**COMMENTS PERTAINING TO PALOS VERDES LANDFILL
TITLE V REVISION**

Prepared by

Henry S. Cole, Ph.D.

Sierra Club South Bay Open Space Task Force

Figure 3: Layout of the Gas Extraction Route

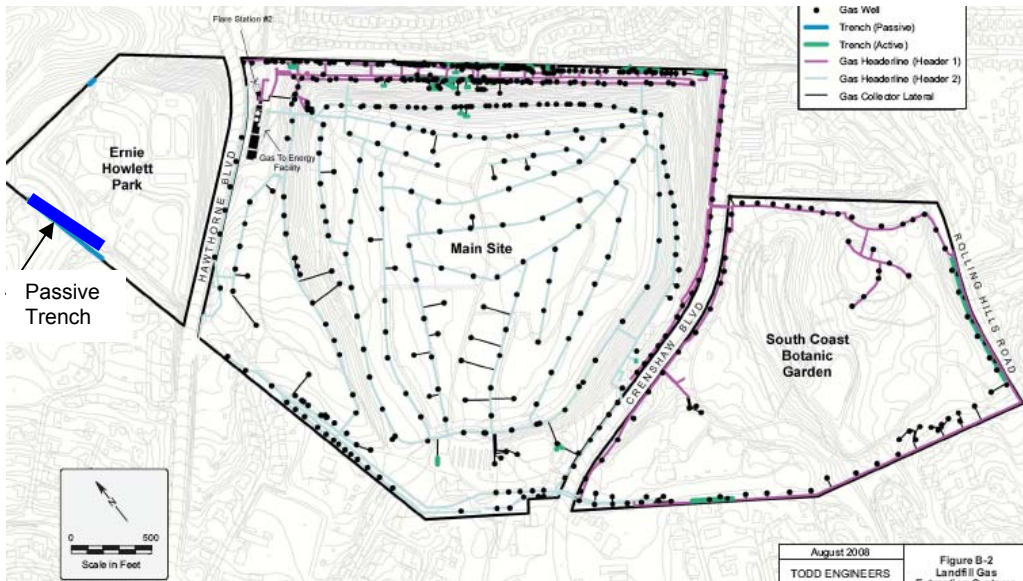
Figures 3 and 4 (From Appendix B of the Five Year Review Document) show that none of the flux chamber measurements used to estimate landfill emissions was obtained from Ernie Howlett Park, an area that has a passive gas trench rather than an active control system and likely to be less effective at controlling emissions. Secondly, none of the flux chamber measurements were made in the South Coast Botanic District.

Lines are the headers. Note the dense network of wells in the area where most of the flux sampling was conducted (Fig 5).

Figure 5: Location of site in relationship to Palos Verdes Fault.

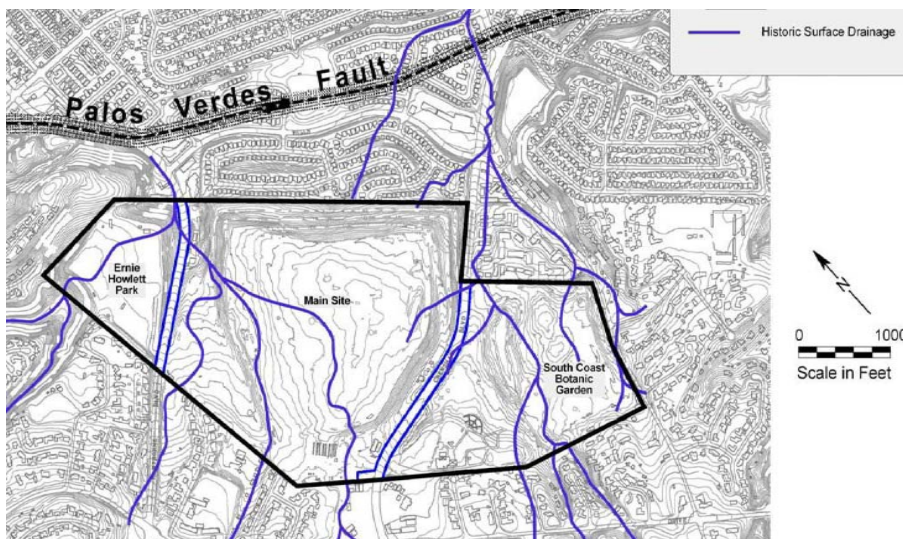
As Figure 5 shows the site lies in close proximity to the Palos Verdes Fault. Dr. Barry Keller previously provided comments on the issue of seismic activity and its potential effects on the site. Keller's submittal states that damage to landfill structures may occur even though the Palos Verdes fault zone does not reach the surface. He strongly recommends consideration of "blind thrust" earthquakes that "can direct strong energy upward in local area, causing extreme damage, even with an intermediate magnitude earthquake."¹ Moreover, as Dr. Keller's comments state ongoing decomposition of landfill materials is likely to cause settlement for many years. Such subsidence can damage result in damage to piping and other critical components of the gas management system.

Fig. 6: Palos Verdes Site 1999

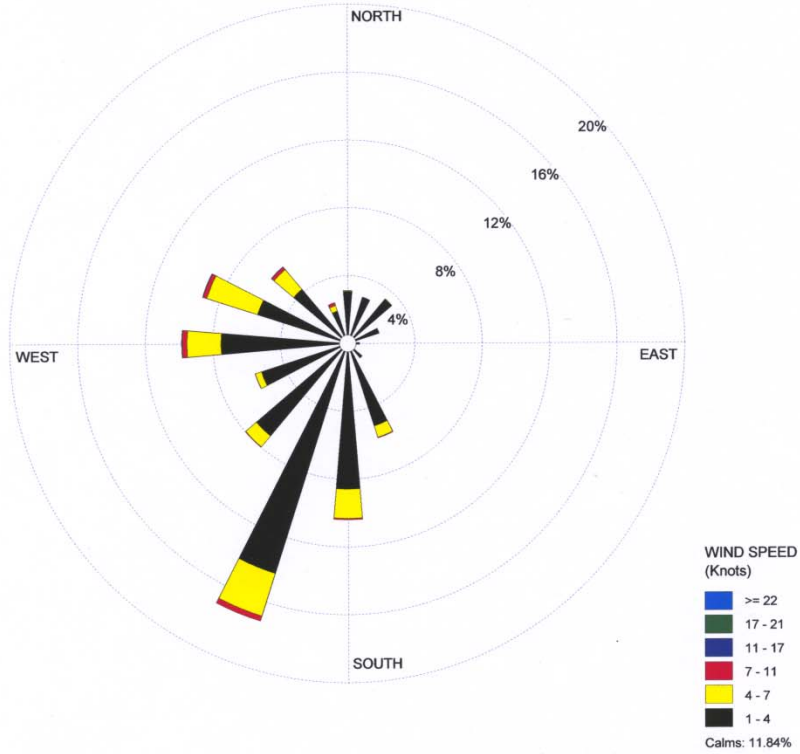
- The Five-Year Review's ISCST3 modeling study used meteorological data from an offsite, coastal weather station at King Harbor. Due to the impacts of the land-sea interface on mesoscale circulation and differences in surface roughness between sea and land, and topographic effects the King Harbor site is not likely to be representative of Los Verdes Landfill with regard to wind direction and wind speed. It is odd that the LACSD modeling used this offsite data when it had an onsite weather station and had used the onsite data to conduct a previous modeling study for the site.⁸ A comparison of the shown in Figures 6 and 7 comparing the wind rose of Palos Verdes and King Harbor (respectively). Note Palos Verdes has a much higher frequency of calms and lower winds speeds (average 2.67 knots) than King Harbor (average 5.52 knots). Had LACSD used local site with lower wind speeds and a higher frequency of calms it's model concentration estimates would have been considerably higher. Although the years used in the two figures are different the differences in wind rose so large is likely the result of geographical rather than temporal differences. However, the burden is clearly on LACSD to show that King Harbor is representative of the Palos Verdes site.

**Fig 7: King Harbor Site
1981**

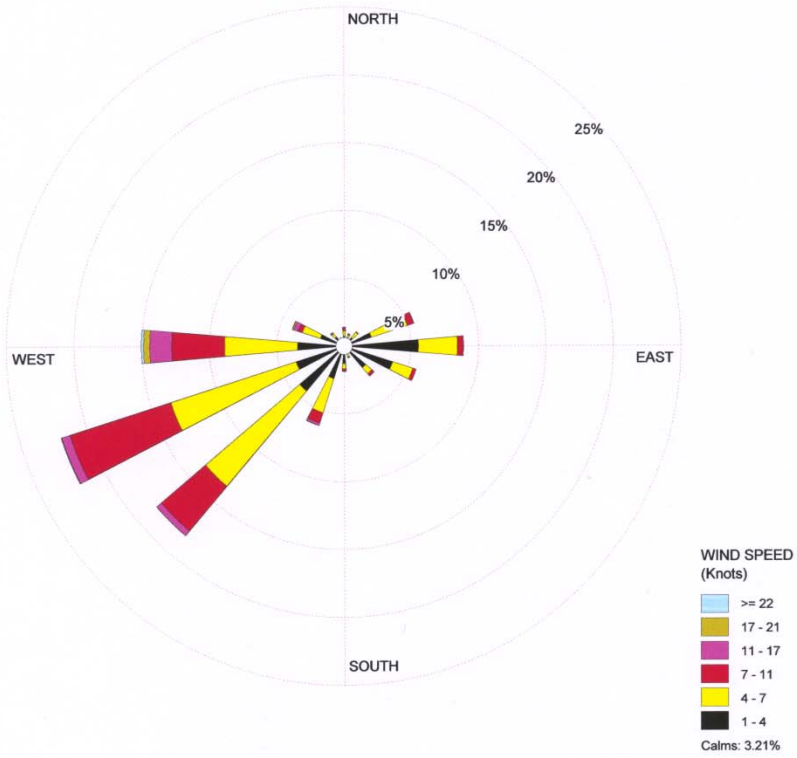
- The Five-Year Review modeling study used on a single year's (King Harbor) data from 1981.⁹ Not only did LACSD miss the boat by using one rather than five-years data, but also picked a year that was more than 25 years previous to 2007, the year when the modeling was conducted. One can only wonder why the year 1981 was selected; clearly more recent years of data are available.
